Expert Report

Estimate in Respect of INTC No. 429

MUDFA programme Revision 8

The Edinburgh Tram Project

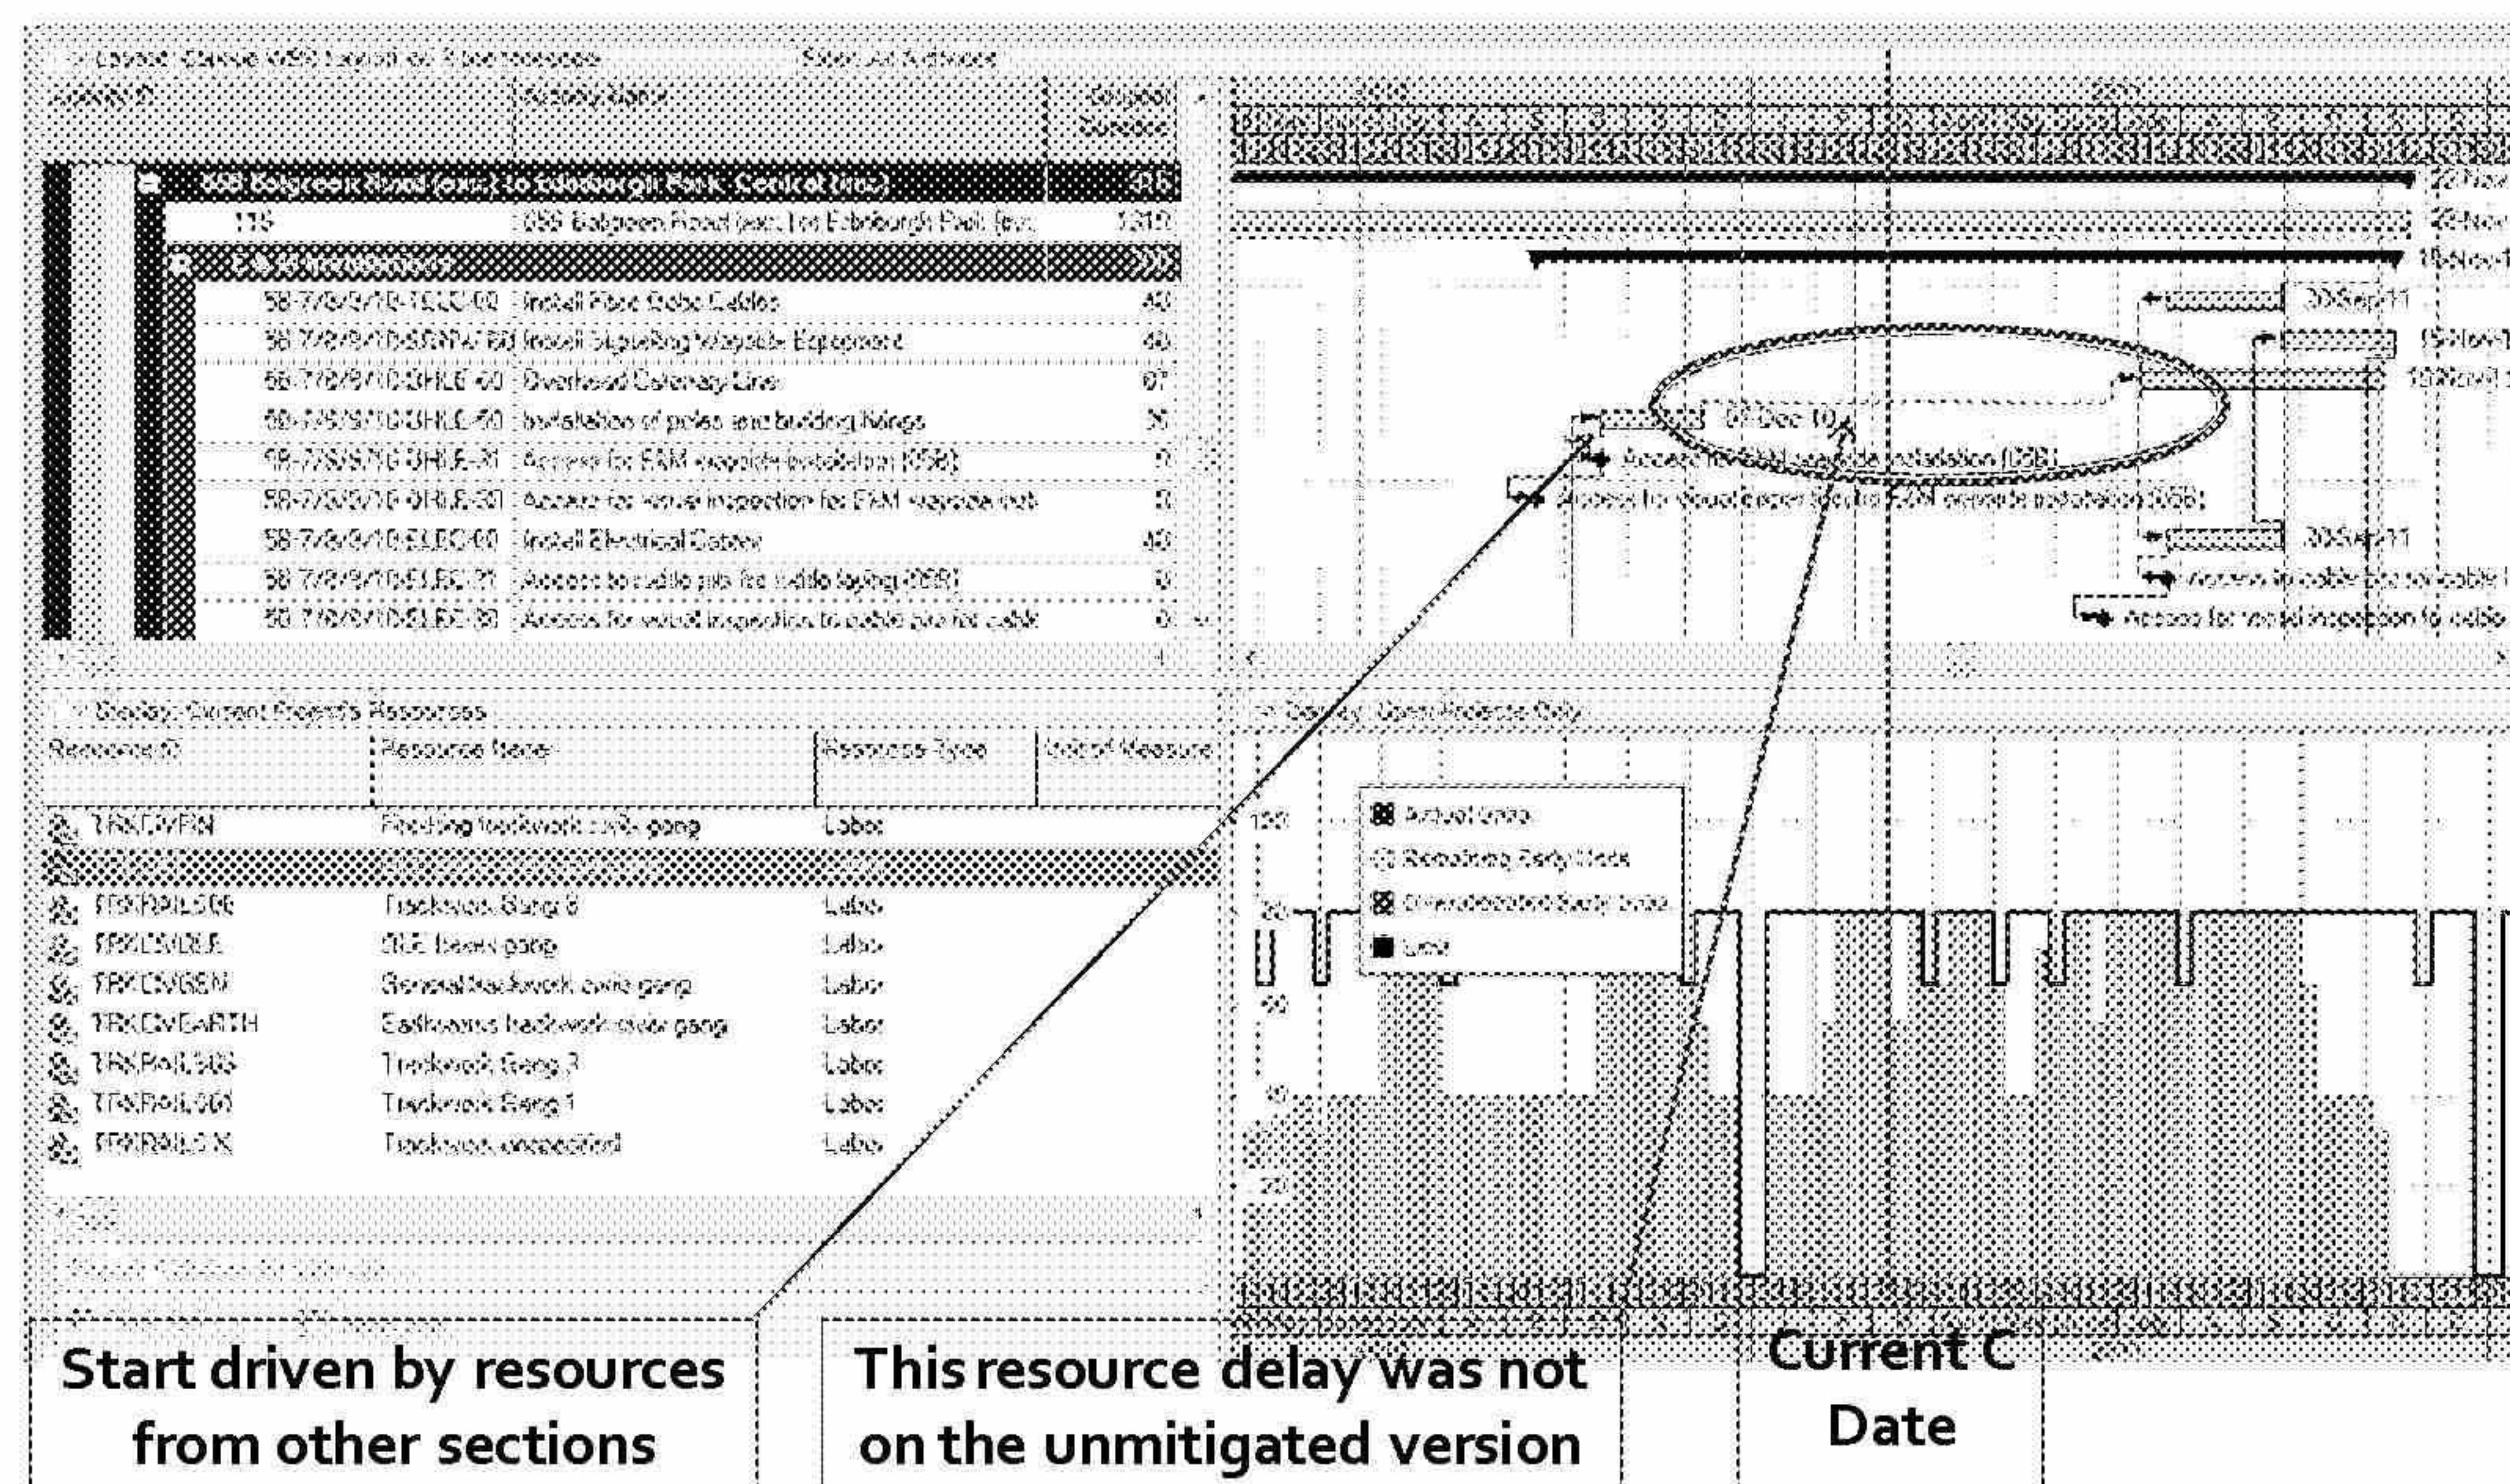
- b) This type of unnecessary and inappropriate logic is not unique and I have not been selective in using it as an example. It is repeated many times throughout the Infraco’s delay analysis and along the length of the route, as evidenced in the schedule at Appendix 5/2. It is clear to me that this is significantly distorting the output from the Infraco’s delay analyses and is giving rise to greatly over-stated projections of overall delay.

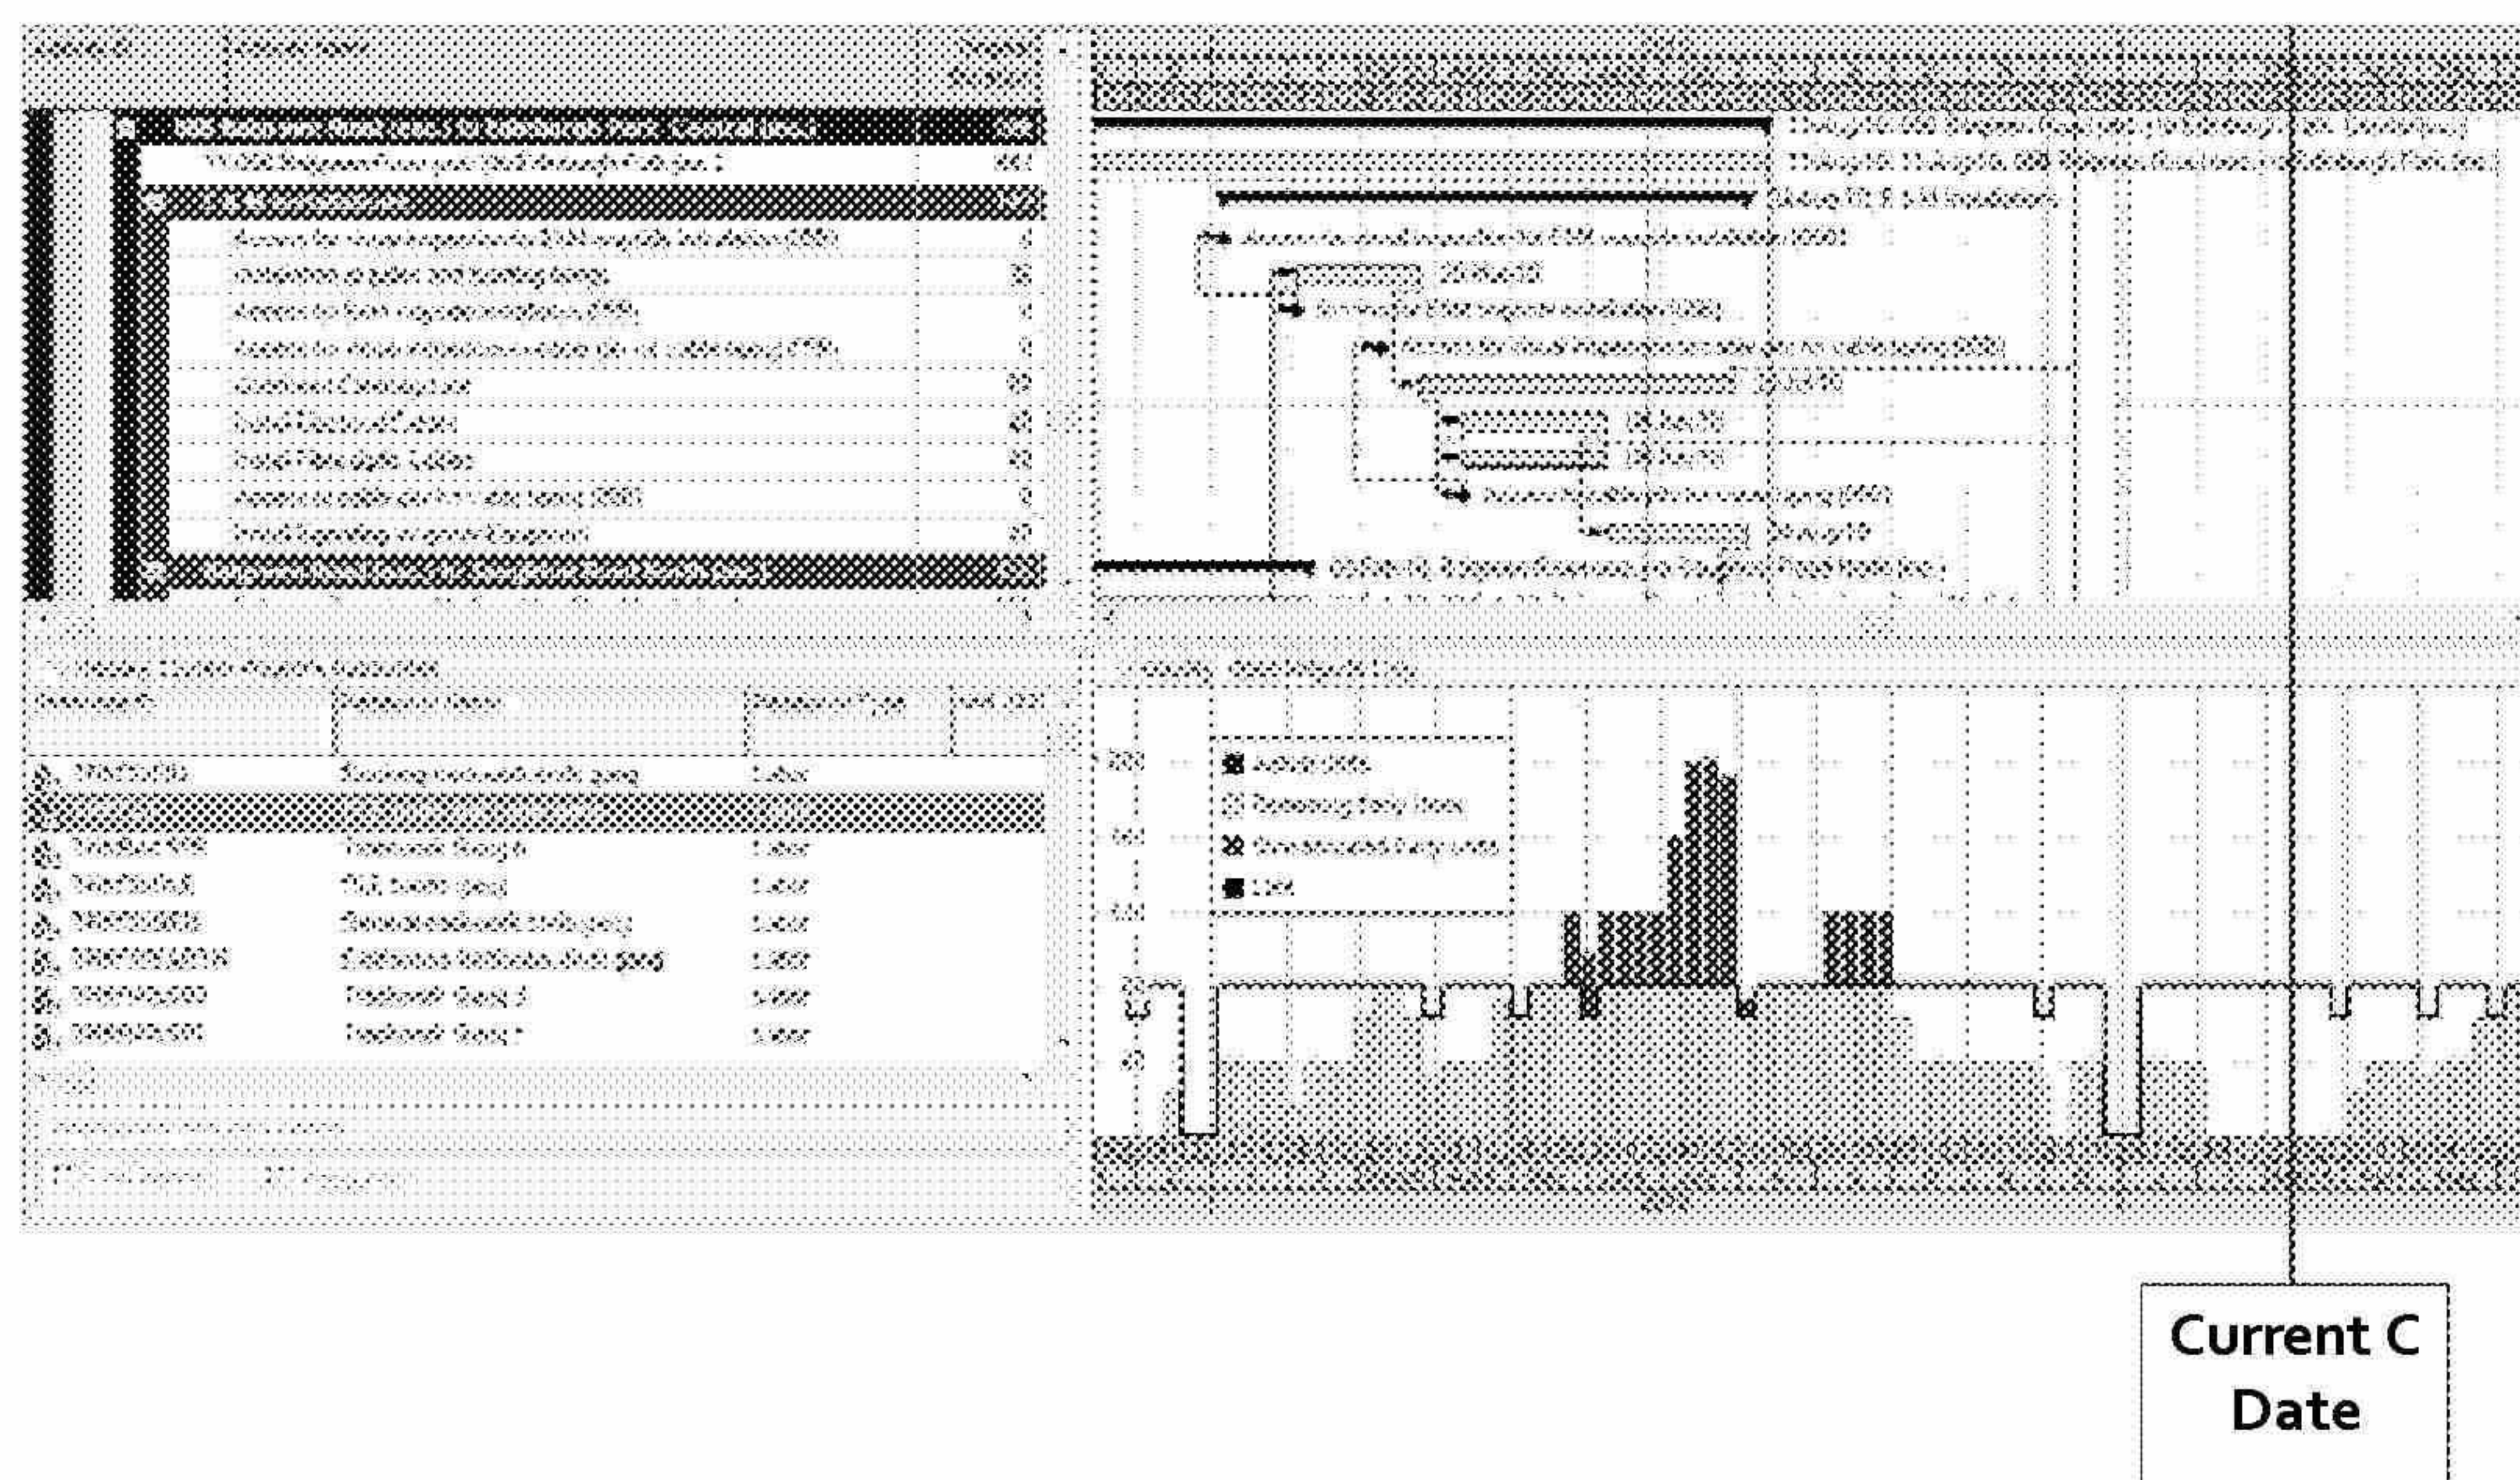
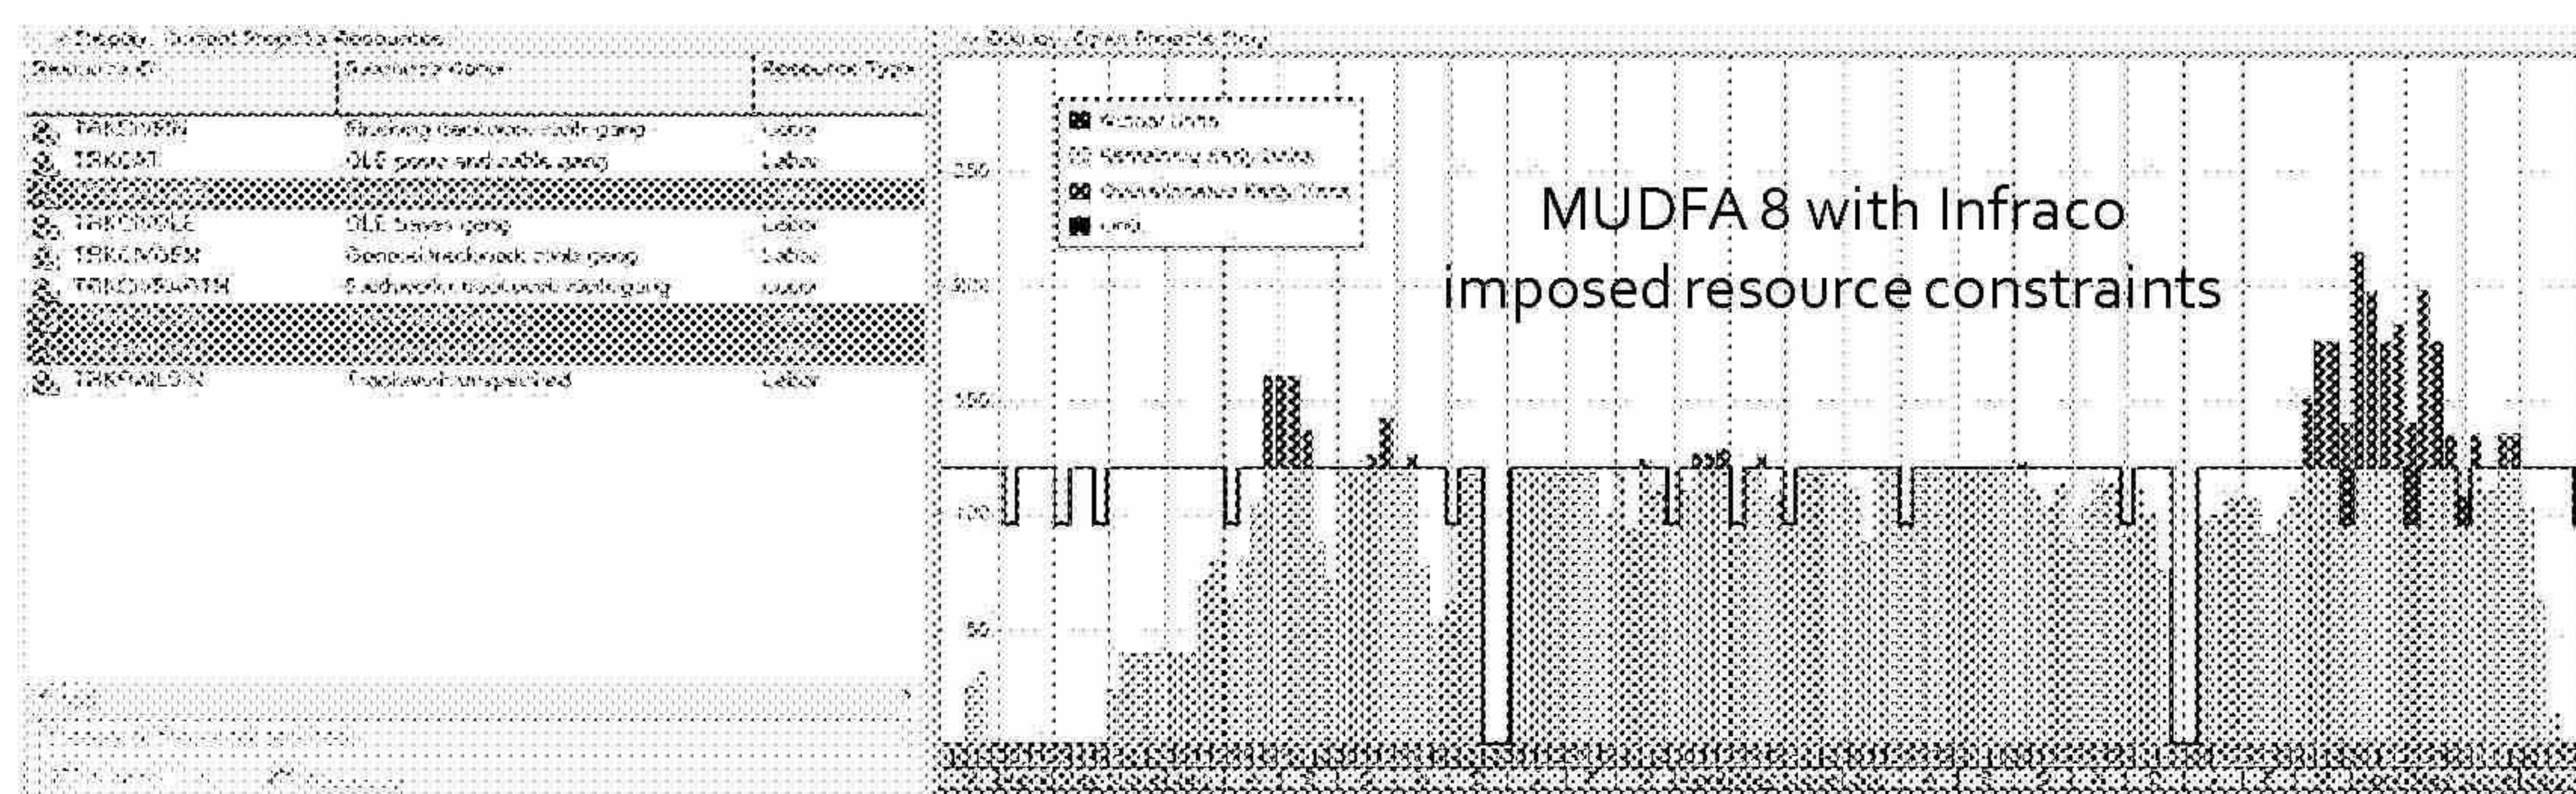
- c) I cite as an example the E&M Installation on Section 5B Balgreen Road (exc.) to Edinburgh Park (inc.). (This is the final section of the critical path to Sectional Completion Date C on the Infraco's delay analysis contained at Appendix D of the Estimate.). Below is the relevant extract from the Appendix D programme. It also shows the resource demand histogram for the overhead line gangs. To this I have added a vertical red line to show the Sectional Completion Date C from the Rev. 1 Programme (i.e. the Sectional Completion Date C current at the time the Infraco submitted the Estimate.) It is readily apparent that four activities and two milestones are projected to over-run the current Sectional Completion Date C by almost 9 months. However, as I have noted by the use of red text and arrows, this projected completion is not being driven by a continuous series of interdependent activities. The installation of poles and building fixings is not starting as soon as it physically could. Its start is being dictated (driven) by a finish to start link from completion of similar work on another section of the project. The work involved is relatively simple and requires a small amount of resources that should be readily available in the market place. The Infraco's apparent strict adherence to its self-imposed resource constraints and the imposition of preferential logic to effect this is creating unnecessary delay to its critical path calculation. I also note that once the poles and building fixings are complete the next item on the critical path (Overhead Catenary Line) is further delayed by approximately seven months by another preferential logic link which I associate with constraining the resources for overhead line works. I again note that there would appear to me to be no reason why additional resources could not be procured to eliminate (i.e. mitigate) this very long delay on the critical path. That said, I note from the overhead line gang resource histogram that within the Infraco's self-imposed resource constraint there is already some availability and that this would increase if the installation of the poles and building fixings was not delayed by similar Infraco imposed resource constraints (as referred to above). I also note that the over-running section of work shown on this programme extract did not extend beyond the current Sectional Completion Date C in the Infraco's unmitigated programme (Appendix C of the Infraco's Estimate). I cite this as further evidence that the projected requirement for extension of time is driven to a great extent by the preferential logic inserted into the programme by the Infraco to meet its self-imposed (and in my opinion inappropriate) resource constraints.

- d) To demonstrate the delaying impact of these preferential logic links I have removed them from this section of the programme network and used the computer software to re-scheduled the programme. The result is shown below.

- e) By removing the computer generated resource constraint, not only is the delay reduced, but this part of the Infraco Works now has a projected completion 7 months **ahead** of the current Sectional Completion Date C. The peak demand for OHLE resource has exceeded the Infraco limit of two gangs but there would appear to be no reason why this could not be overcome by employing an additional gang of men and equipment (thereby increasing the available resource from 80 units to 120
